Commonwealth Edison

Subject: LaSalle County Station Unit 2
Facility Operating License NPF-18
Condition No. 4 of Attachment 2
NRC Docket No. 50-374

This letter is submitted to comply with a LaSalle County Station Unit 2 license condition [reference (a)]. The attachments to this letter constitute a procedures generation package to upgrade LaSalle's emergency operating procedure to BWR0G Rev. 3.

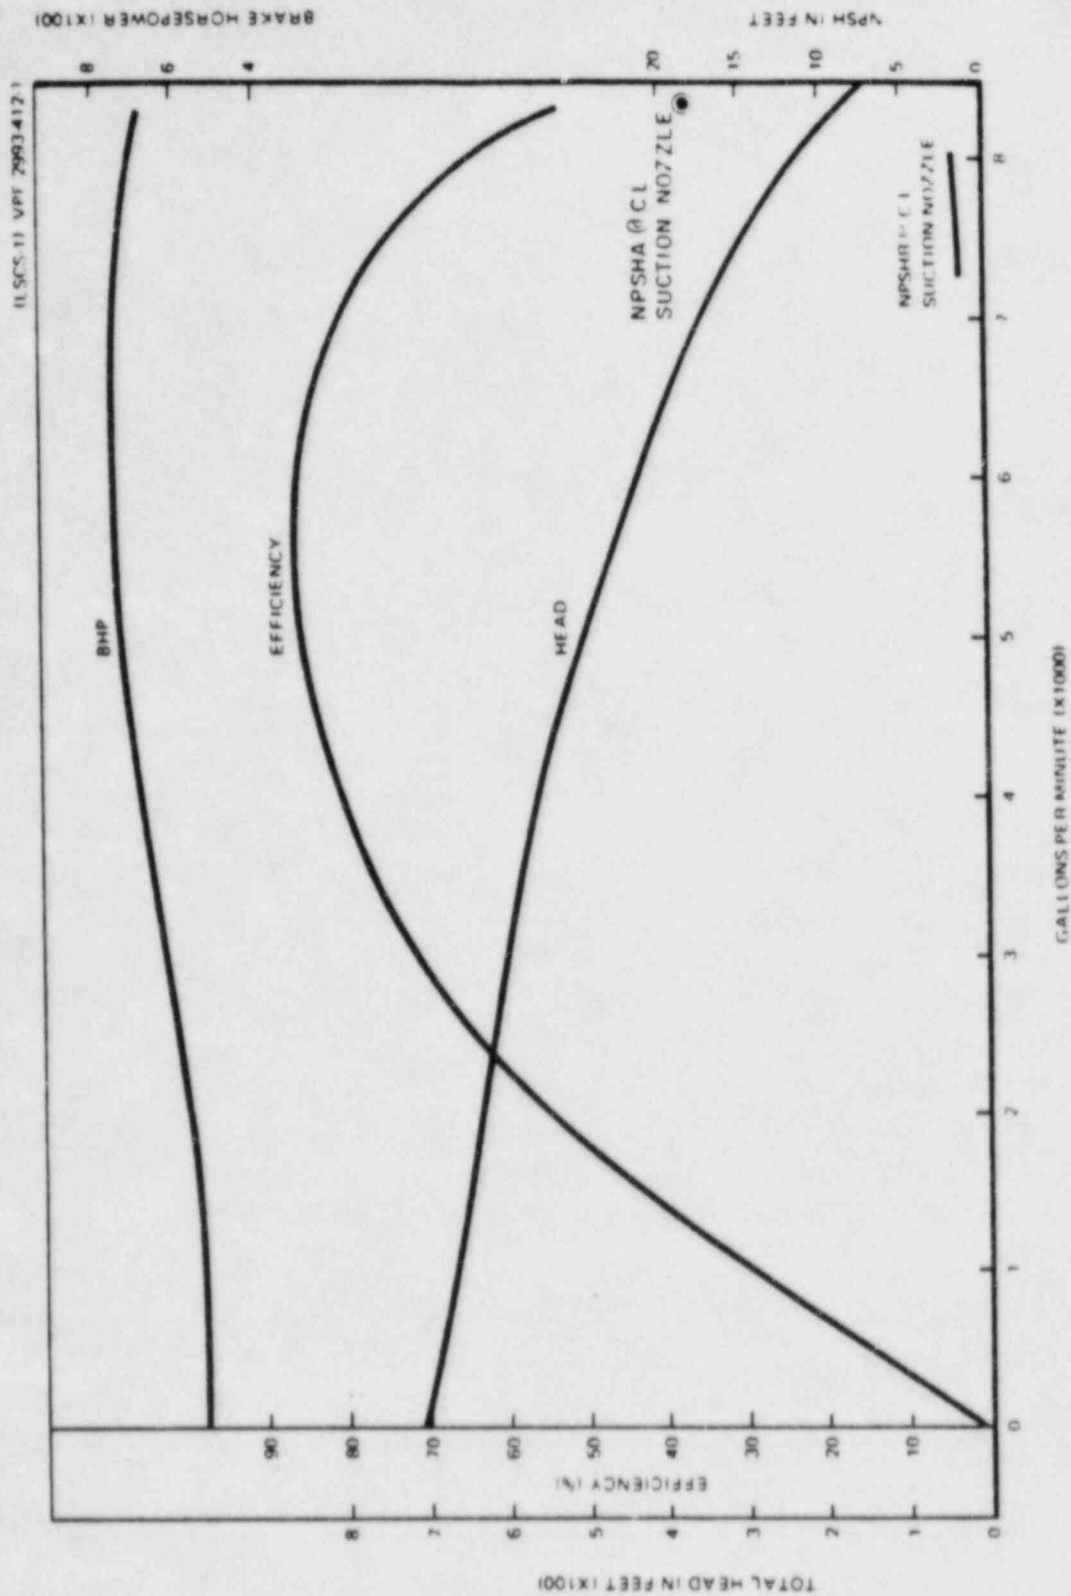
Since the Technical Specifications permit MSIV isolation in hot standby, this should not require entry into the RPV Control Guideline and a subsequent scram per Step RC-11 the entry condition needs to be limited to isolations which require a scram.

Resolved entry conditions deleted as it is no longer required with Radioactivity Release Control Guideline.

J

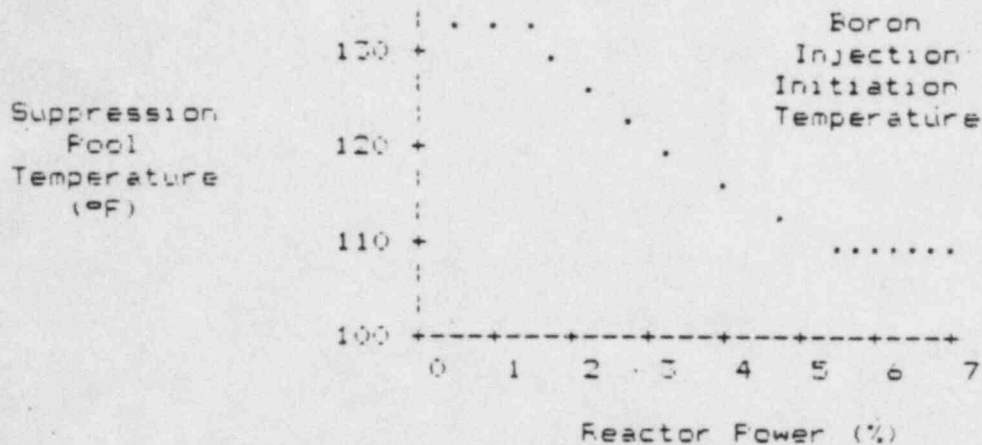
Rod insertion criteria should be "...rods at or beyond [06..",
not "...rods beyond [06..".

Resolved all references
to rod insertion criteria
changed to "...at or beyond
[06..".

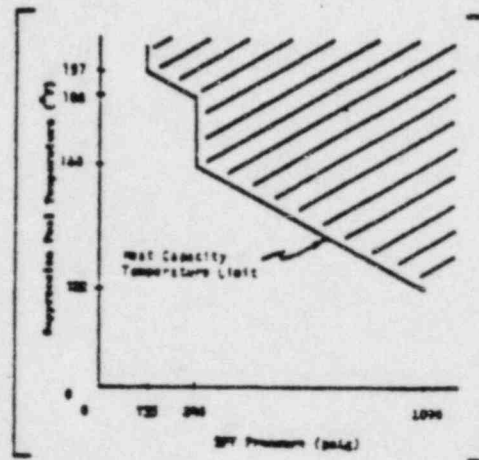
The manual scram should be initiated only after the SDV has had a chance to drain; the step needs to reflect this waiting period.

Resolved changed step to
read "Drain the scram discharge volume and initiate a manual reactor scram;" utilities to discuss proposed change with operators and prepare for discussion at next EPC meeting.

Resolved 5/10/84: step changed as proposed.
